CITY OF ALBUQUERQUE

RE: Tierra Serena (Glendesto) Subdivision
Revised Grading Plan Stamp Date: 1/23/18
Certification Dated: 5/9/18
Hydrology File: B18D020

GLENDESTO SUBDIVISION GRADING & DRAINAGE PLAN

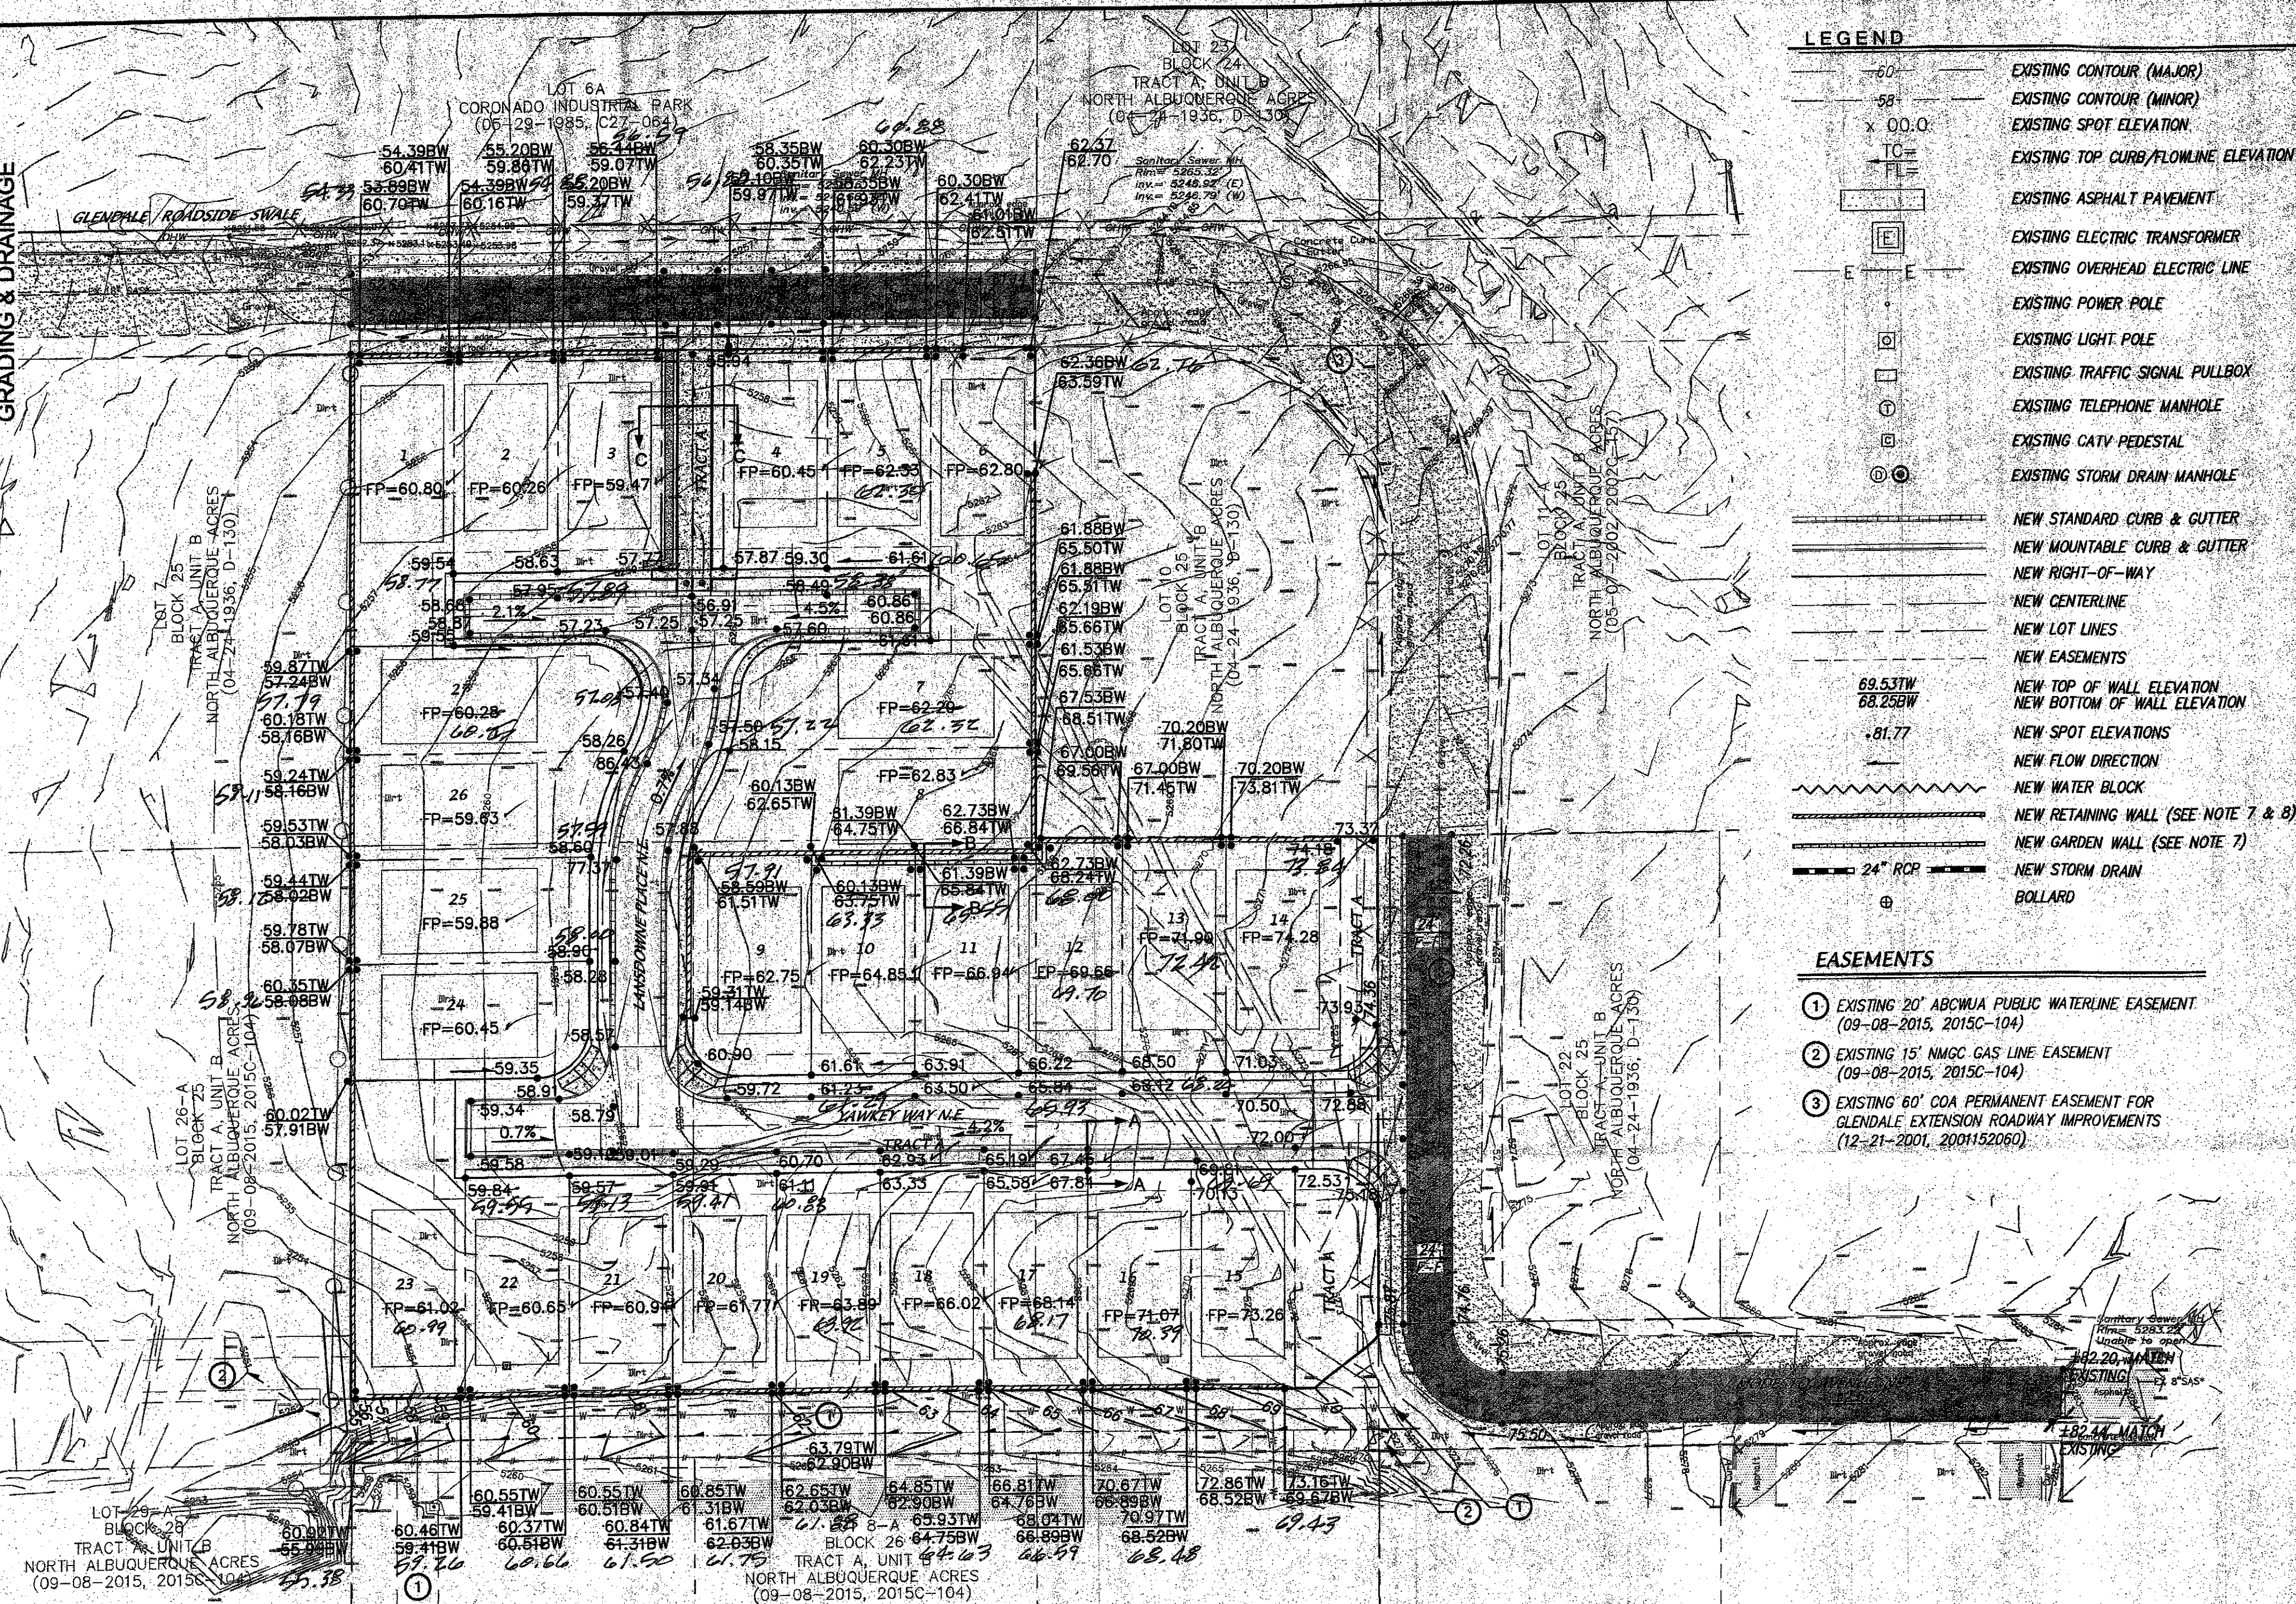
Based on your submittal received on 5/10/18, the engineer's certification cannot be accepted for pad certifications until the following are completed:

1. The retaining walls need to be completed, backfilled (both sides), and surveyed (top of wall and bottom of wall).
2. For each pad requesting certification: the pad, all 4 lot corners, and the flowline in the street need to be obtained. Additional spot elevations showing flow paths, retaining walls and drainage features need to also be obtained as applicable to the individual lot.
3. The water and gas easement behind lots 15-23 needs to be restored. Fill placed against the wood fence needs to be removed, the flowpath needs to be redefined down the center of the easement, not against either the wood fence or the new retaining wall. This area also needs to be reseeded and stabilized against erosion with check dams and gravel mulch.
4. All other offsite areas distributed as part of this project need to be restored and reseeded as well.

Once these corrective actions have been taken, a new certification will need to be requested; please be sure to indicate which pads are being certified or if release of financial guarantee is being sought. If you have any questions, please contact me at 924-3695 or dpeterson@cabq.gov.
